NESS EFW Limited (SC627853) NESS EfW Facility

Permit Application PPC/A/1186430

Permit (Application) Number: PPC/A/1186430

Applicant: NESS EFW Limited (SC627853)

Figure 7: Human receptor locations

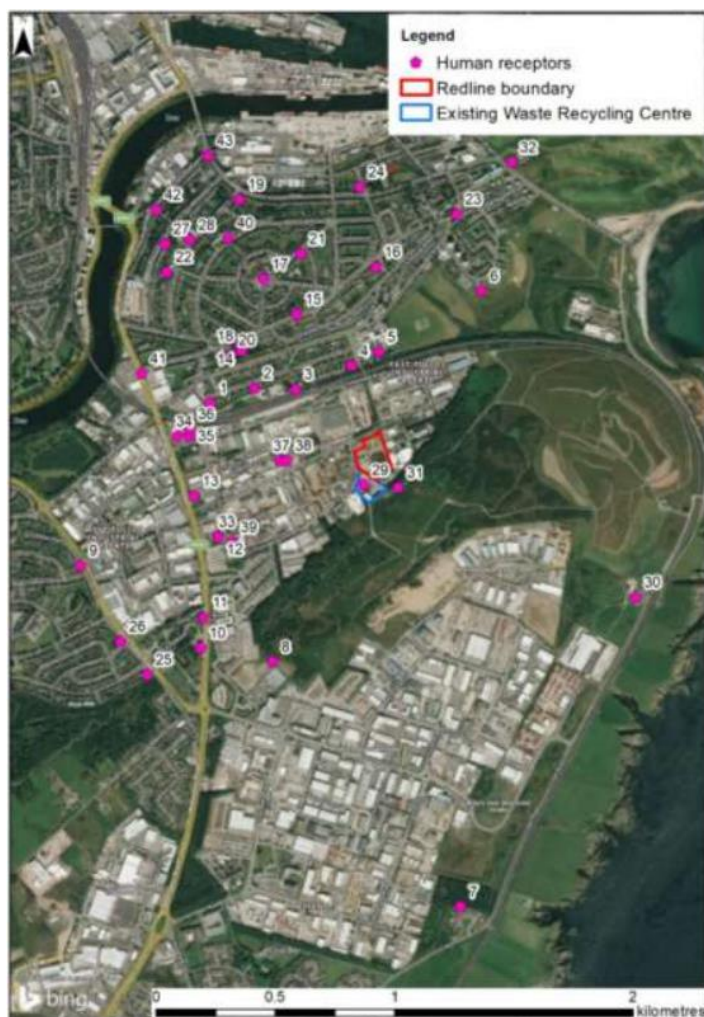
These receptors are presented in Table 10 and Figure 7 of the Air Quality Assessment report provided as part of the application and updated in response to SEPAs Notice requiring further information. These are replicated below for ease. SEPA have determined that the identified receptors accurately represent those at risk within the immediate environment.

Figure 8: Ecological receptors (nearest to the EfW facility

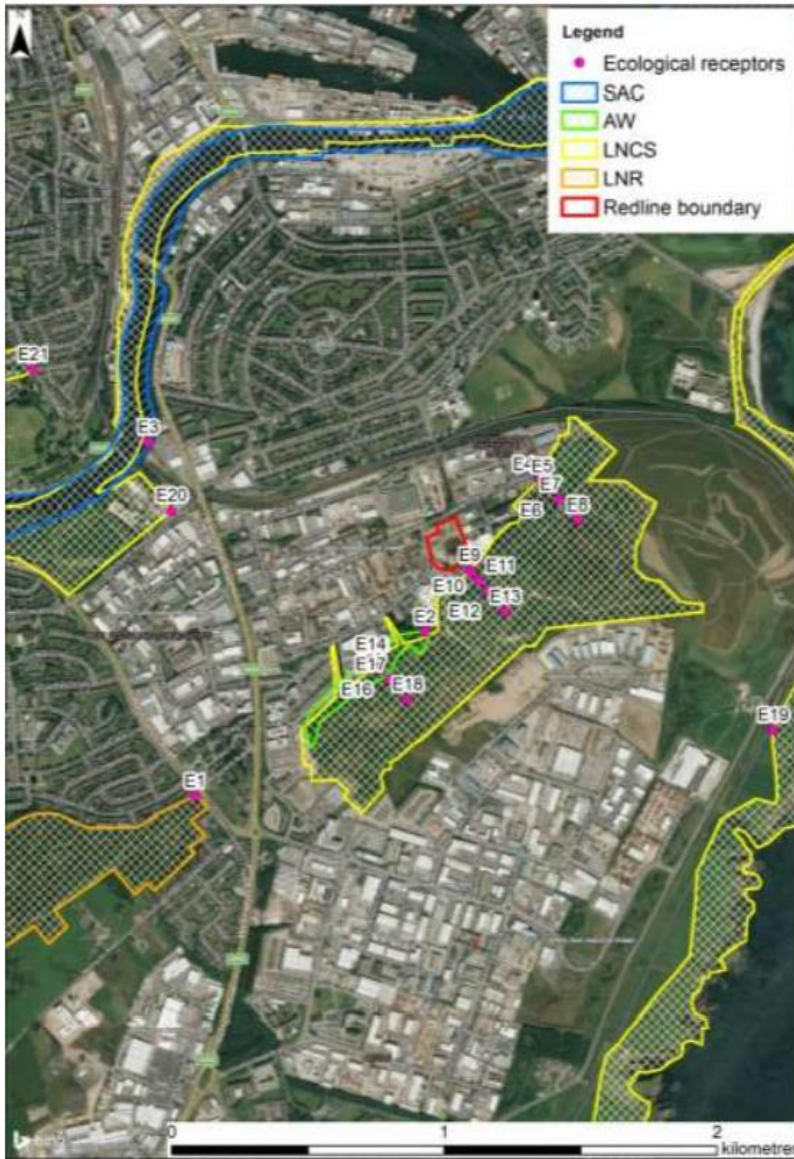
These receptors are presented in Table 11 and 12 as well as in Figure 8 and 9 of the Air Quality Assessment report provided as part of the application and updated in response to SEPAs Notice requiring further information. These are replicated below for ease. SEPA have determined that the identified receptors accurately represent those at risk within the immediate environment. See

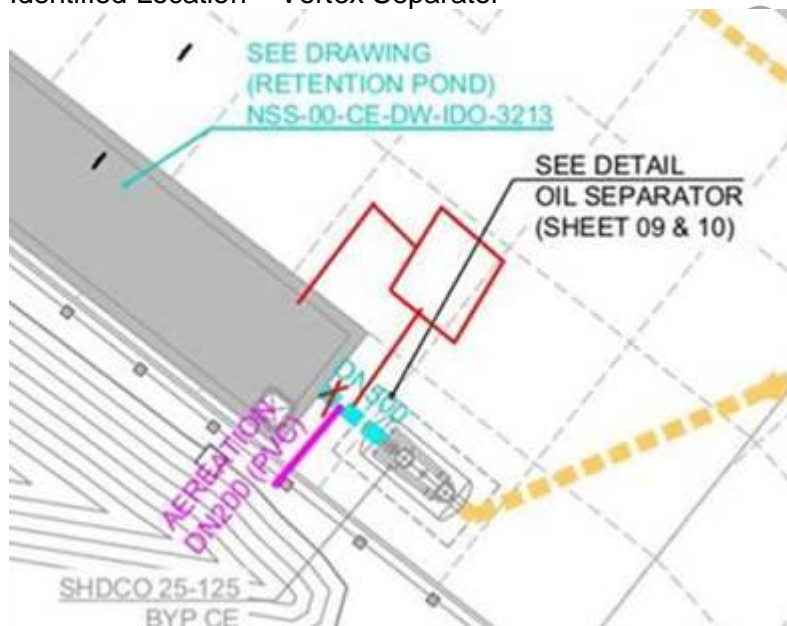
'Due to spatial constraints, and to avoid the risk of cross contamination between the off-site pollution control perimeter drain and the on-site surface water, it has become necessary to remove the approved perimeter filter drain. The effect on the SuDS mitigation indices is demonstrated in

the attached re-assessment. The reassessment shows that the SuDS elements alone do not meet the requirement with a shortfall of 0.3 for TSS, Metals and Hydrocarbons.'

The acceptance of a lower level of SUDS treatment, identified as not meeting the required standard, for what is an unqualified risk from a potential offsite source without presenting a robust justification was not considered to be credible. Further justification for the proposed change and information relating to the potential risk from the wider drainage system and the site water balance was therefore sought.

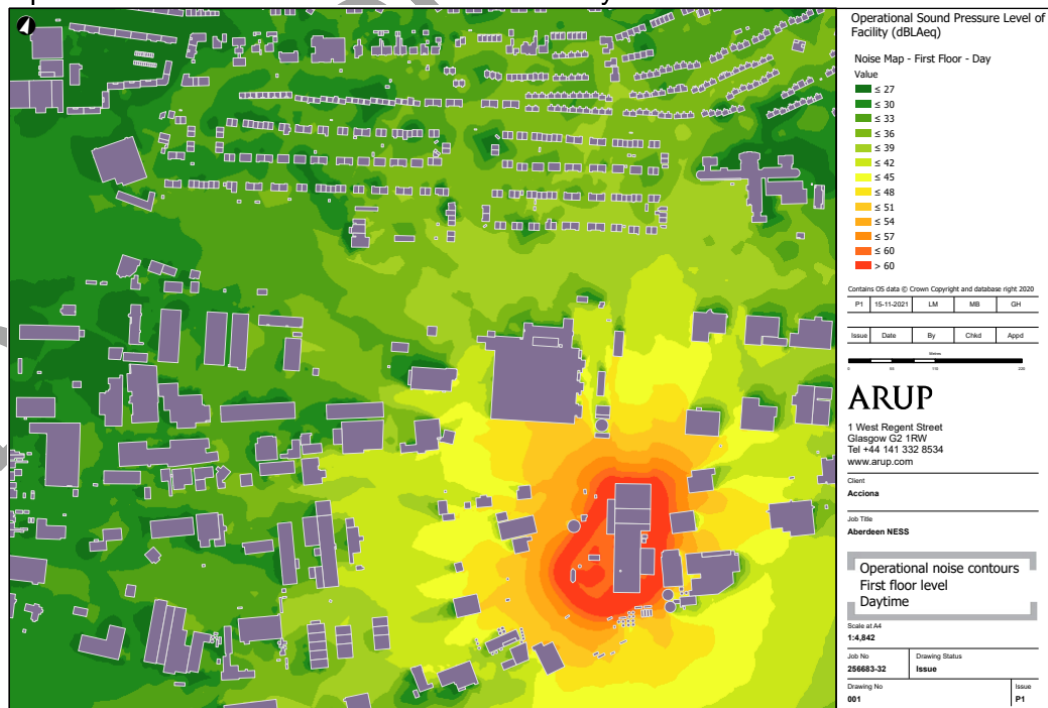
- Updated facility design and equipment with plant items such as the chiller, secondary circuit pumps etc. having been removed, other items such as the MV-Switch rooms have been moved inside, additional sources identified new exhaust fans etc. as well as confirmation that the vacuum skid and the ACC have guaranteed at a value of 75dBA at 1m combined. Therefore, only one noise source has been modelled in the worst case location (previously 2).

- The previous submission identified that there were 28 receptors at 3dB or more above background at night time of which 8 were +5dB, but now there are only 3 receptors at 3dB or more above background at night time and all are less than +5dB.

Operational noise contours First floor level Night-time

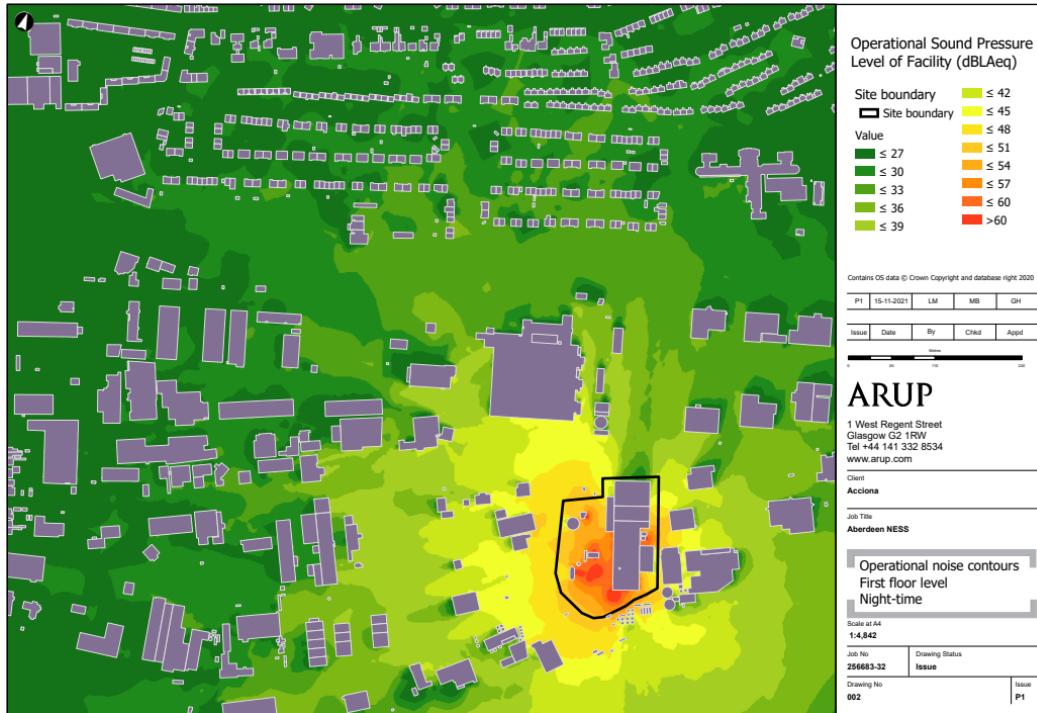
The identification of potential sources of noise and their subsequent impact is considered to be sufficient and the techniques described in order to minimise the generation of noise from the proposed facility, when taken into account the further confirmation sought by the included draft Conditions, are determined to represent BAT.
